World Forum for Harmonization of Vehicle Regulations

Working Party on Noise and Tyres

Tyres: UN Regulation No. 106 (Tyres for agricultural vehicles and their trailers)**Proposal for amendments to UN Regulation No. 106****Submitted by the experts from the European Tyre and Rim Technical Organization***

"Part C: Implement tyres

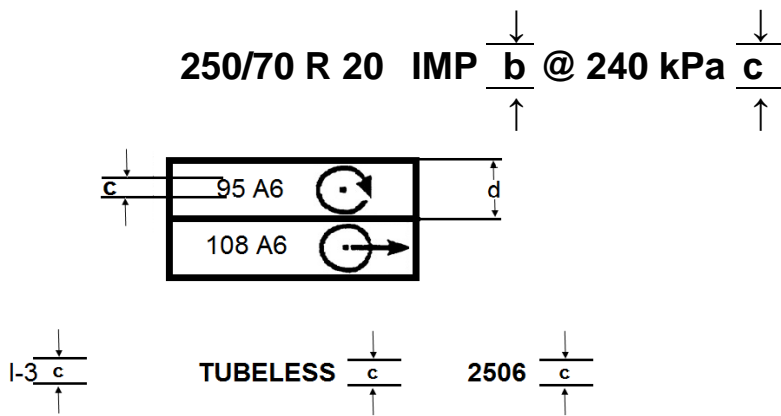
Annex 3, Part C, amend to read:

- (a) The **tyre** size designation, comprising **the prefix (if any)**, the nominal section width, the nominal aspect ratio, the type-of-structure symbol (where applicable), the nominal rim diameter and optionally the letters 'IMP' must be grouped as shown in the ~~above example~~**examples**:
250/70 R 20 IMP, **VF 650/55 R 26.5 IMP**;

"Annex 10

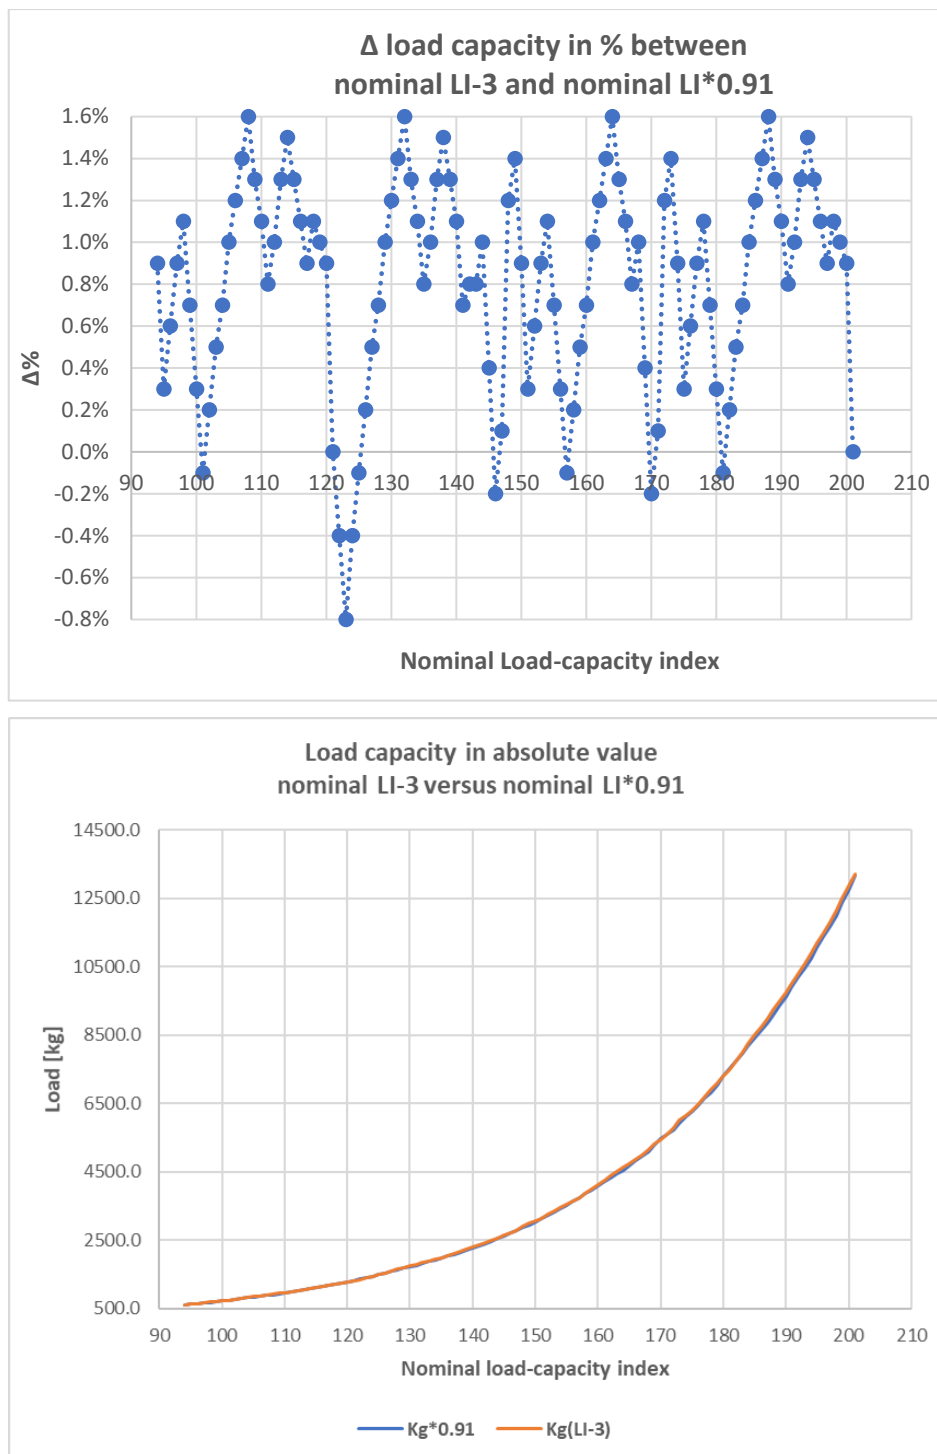
Annex 10, amend to read:

9. It is proposed to introduce the classification code “F-2M” currently standardized by tyre industry and used as an alternative to the marking F-2 in case of agricultural tyre with multiple rib tread.

Classification code	Nomenclature
F-1	Agricultural tractor steering wheel tyres: single rib tread
F-2 or F-2M	Agricultural tractor steering wheel tyres: multiple rib tread
F-3	Steering wheel tyres: industrial service (construction application)
